Specification for 100GBASE-DR4

Piers Dawe

Recommendation – detail 1

Figure 96–3—Transmitter minimum OMA

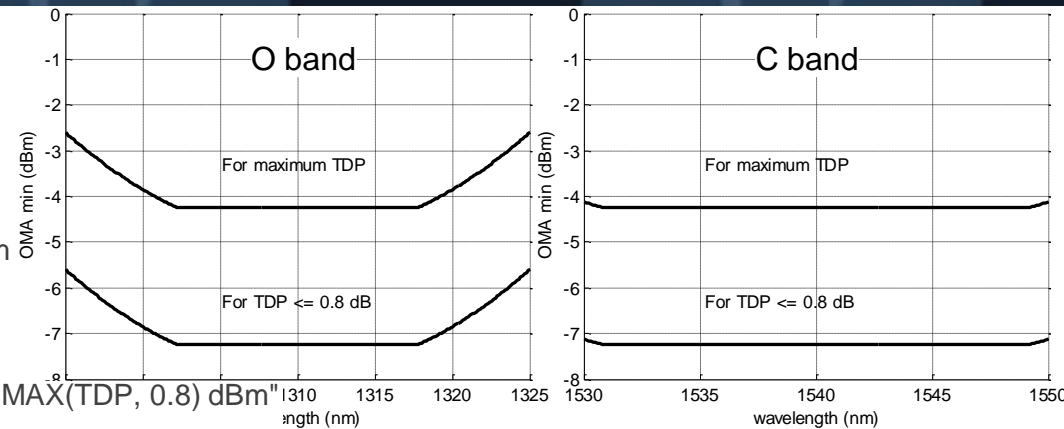
96.7.1.1 Transmitter OMA, each lane (min)

- Add 1550 nm option: change
- "Tx_OMA \geq MAX(-8.65+((lambda-1310)^2)/100, -8.05) + MAX(TDP, 0.8) dBm"
- to
- "Tx_OMA \geq {MAX(-8.65+((lambda-1310)^2)/100, -8.05) + MAX(TDP, 0.8) dBm
- or
- Tx_OMA \geq {MAX(-8.65+((lambda-1540)^2)/138.2, -8.05) + MAX(TDP, 0.8) dBm"

Figure 96–4—Receiver sensitivity

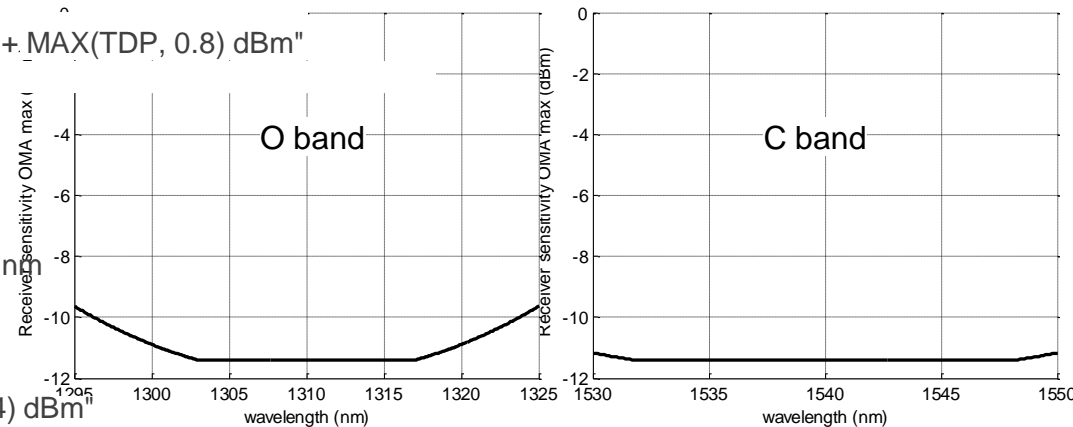
96.7.2.1 Receiver sensitivity (OMA), each lane (max)

- Add 1550 nm option: change
- "Rx_sens \leq MAX(-11.89 + ((lambda-1310)^2)/100, -11.4) dBm"
- to
- "Rx_sens \leq MAX(-11.89 + ((lambda-1310)^2)/100, -11.4) dBm
- or
- Rx_sens \leq MAX(-11.89 + ((lambda-1540)^2)/138.2, -11.4) dBm"

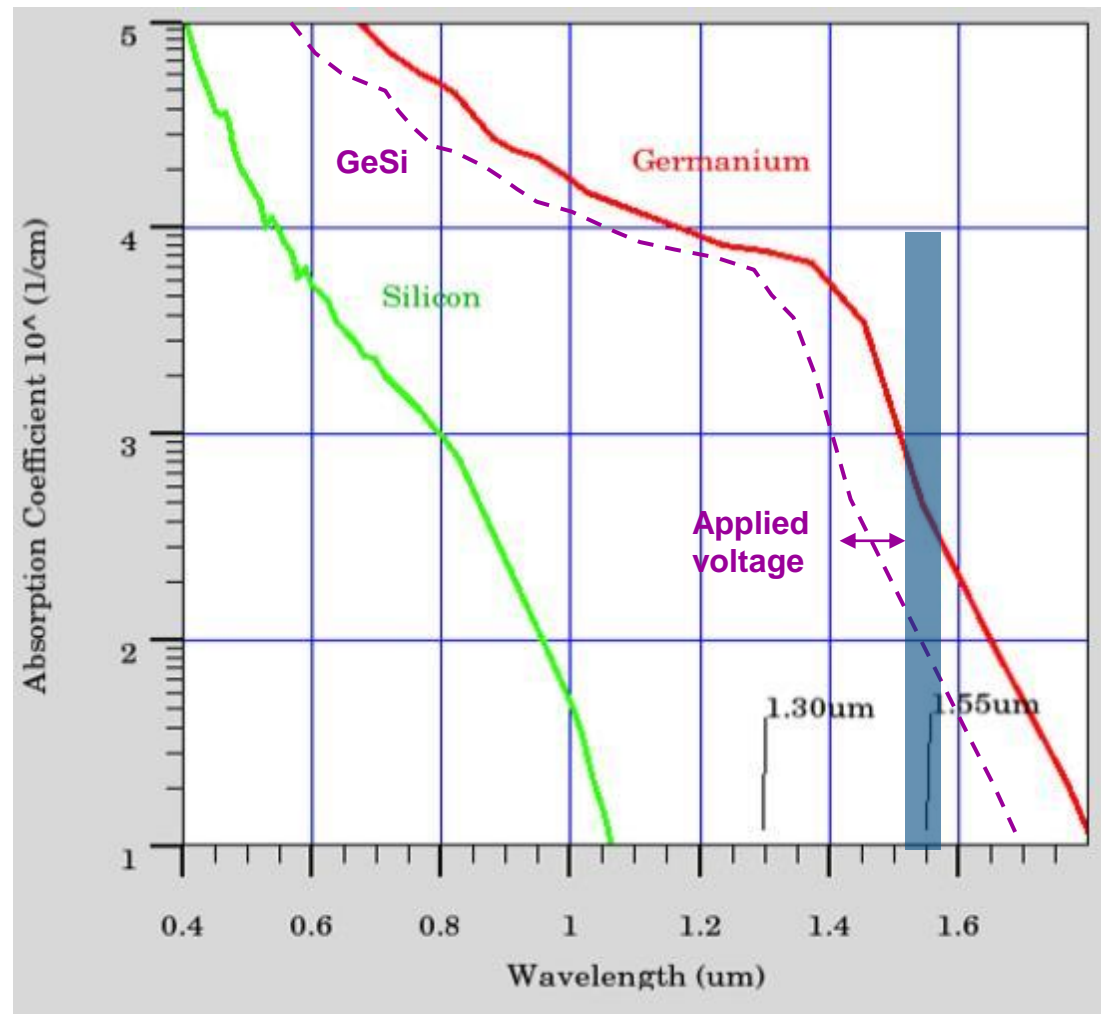
- Table 96–7—100GBASE-?R4 receive characteristics
- The MDI connector is an angled type, so **Receiver reflectance** (max) –12 dB is not necessary
- Change Receiver reflectance (max) from –12 to –20 dB
- In Table 96–6—100GBASE-?R4 transmit characteristics, adjust **Optical return loss tolerance** (max), presently 7.94 dB, appropriately
- In Table 96–11—Transmitter compliance channel specifications, for **Optical return loss**, change TBD to the modified Optical return loss tolerance (max) from Table 96–6
